**Subject:** RE: Additional Information Request for A/Ns 657635-7 submitted for Chiquita Canyon landfill (ID 119219) for the hazardous waste liquid treatment systems

**Subject:** Additional Information Request for A/Ns 657635-7 submitted for Chiquita Canyon landfill (ID 119219) for the hazardous waste liquid treatment systems

I have been assigned the applications (A/Ns 657635-7) submitted for Chiquita Canyon landfill (ID 119219) for the hazardous waste liquid treatment systems and associated TV Revision. I have reviewed the provided information and have determined that additional information is required. Pursuant to Rule 210, the applications may be denied if the necessary additional information is not submitted. Please provide the following information by **February 25, 2024**, so I may proceed with processing these applications:

## Tank Farm 9 Layout

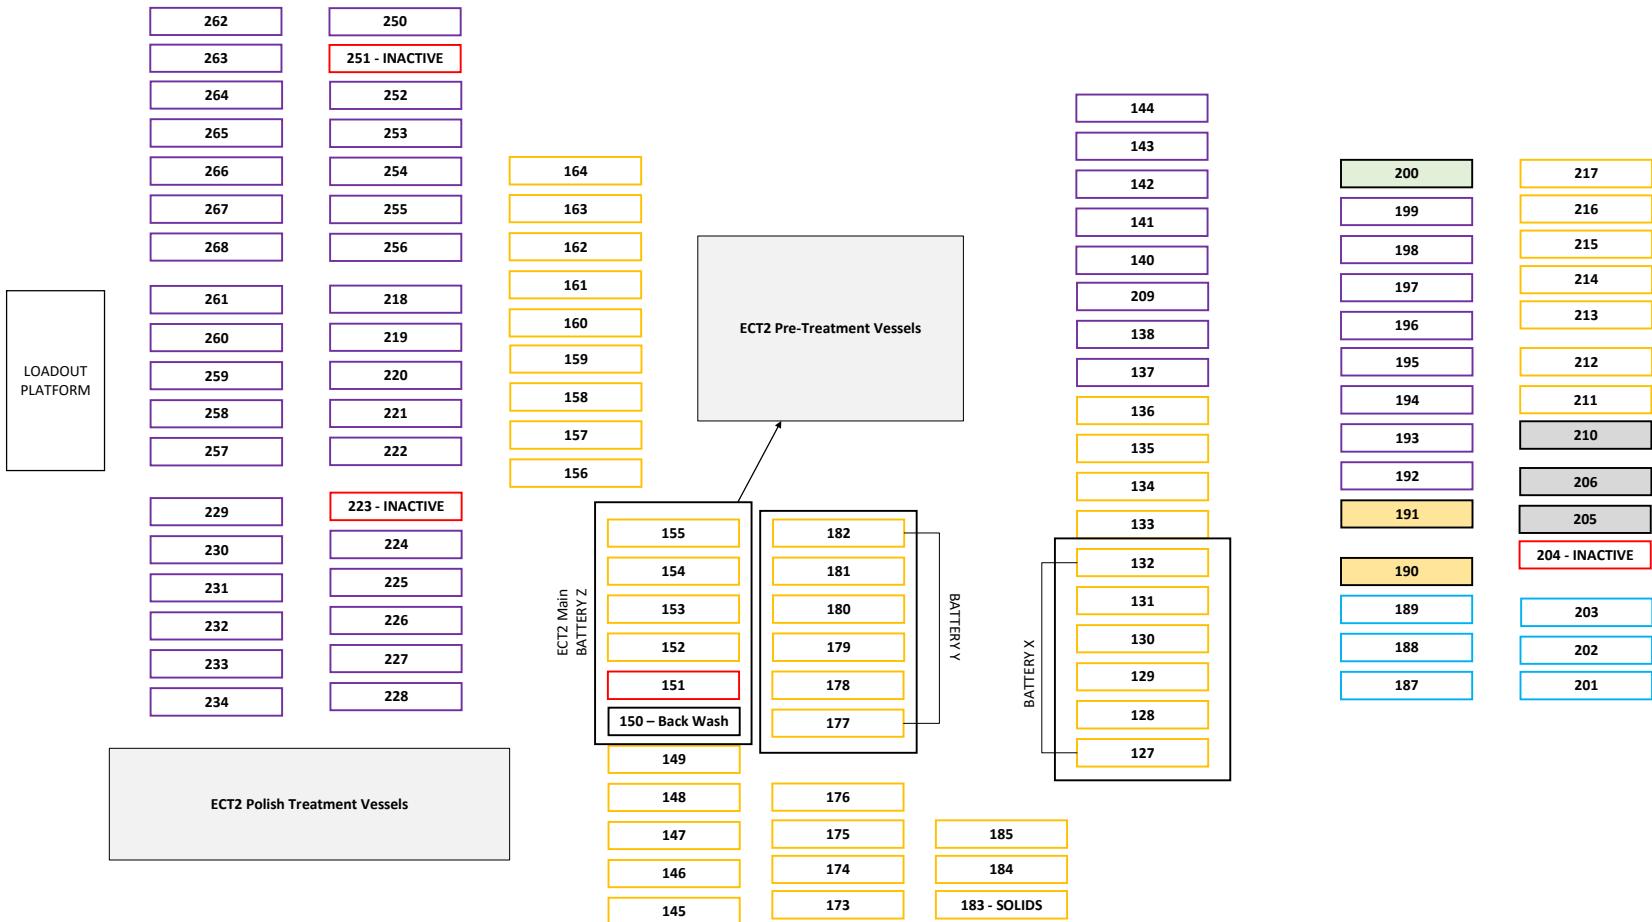
- \* For the system located at Tank Farm 9, will the system also backwash? If so, please update the process flow diagram accordingly. Yes, the system also backwashes and the attached layout shows the updated layout with backwash. It is set up the same as Tank Farm 7 in that the backwash can be applied to the carbon vessels and the sand filters.

## TF7 Process Flow Diagram

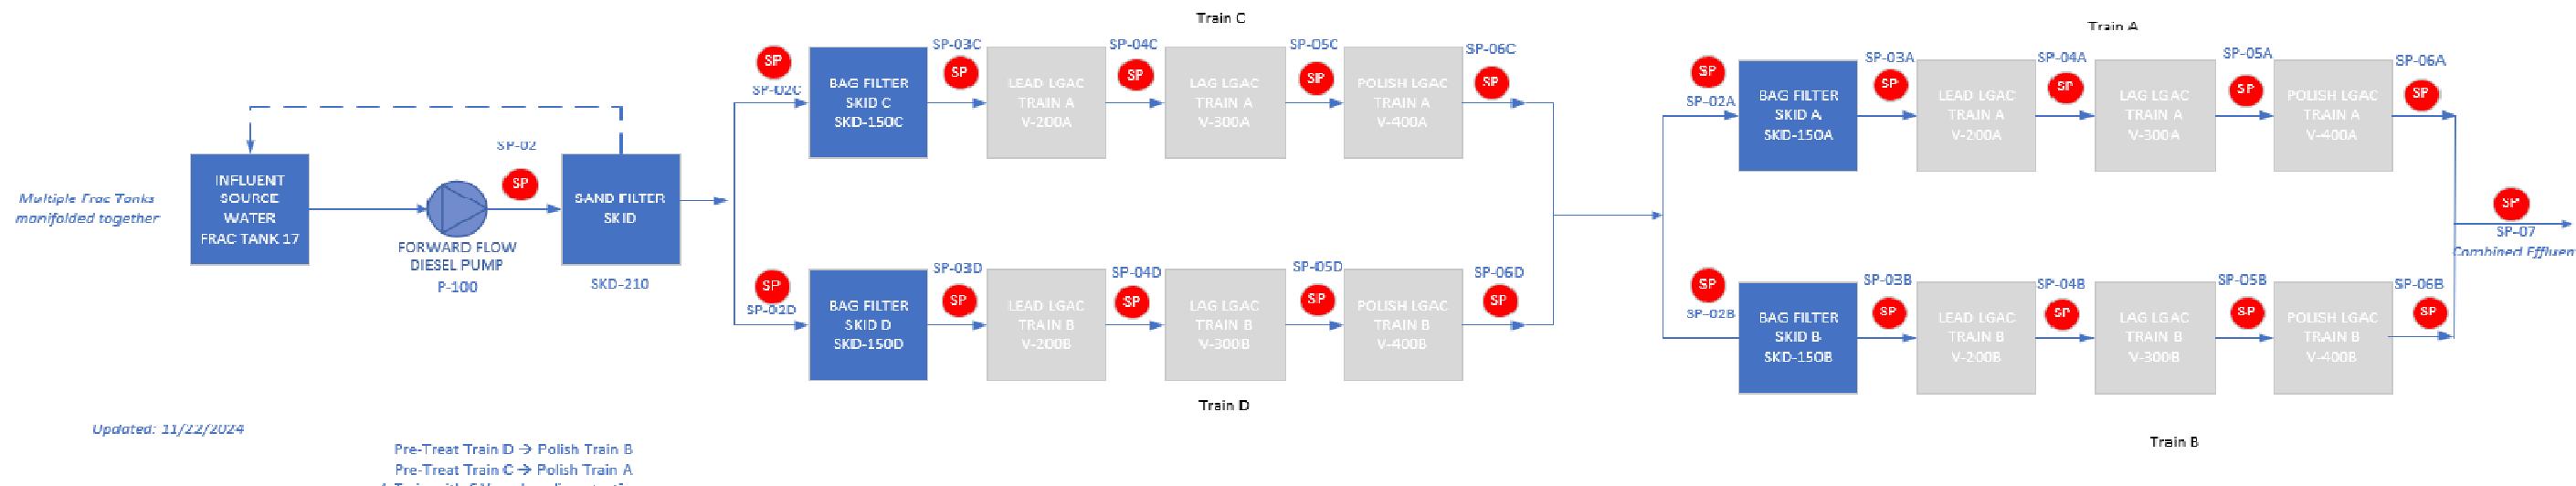
- \* For the system located at Tank Farm 7, please confirm there are 3 trains consistent with the process flow diagram, not two trains as listed in the ECT2 Forward Flow Operation detail. There are four trains of 3. An updated PFD is attached.

- \* Provide an explanation on why the leachate in Tank Farm 9 is treated with 2 parallel trains in series with 2 additional parallel trains, while the leachate in Tank Farm 7 is just treated with 3 trains in parallel. As noted above, there are four trains of 3; but note the treatment vendor would like to reserve the right to treat the waste however is most conducive to the expeditious dewatering of the hill, and therefore requests flexibility on the configuration if possible. An updated PFD is attached.
